Kaci - looks
good. I noted a
few comments.

Concept Paper on Data Product Change Management

Submitted to the Market Data Working Group on Month DD, YYYY.

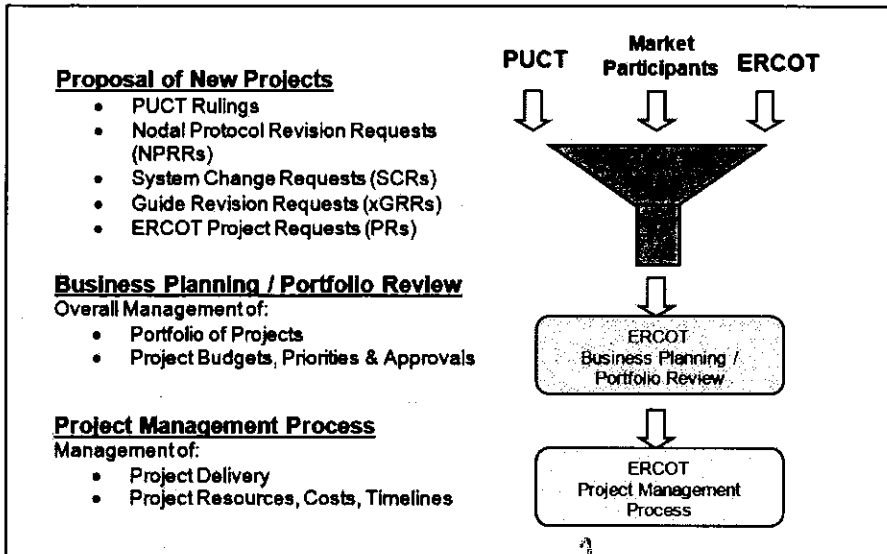
by whom?

by whom?

Is this process internal to ERCOT? If "yes", may want to clarify as such agreed
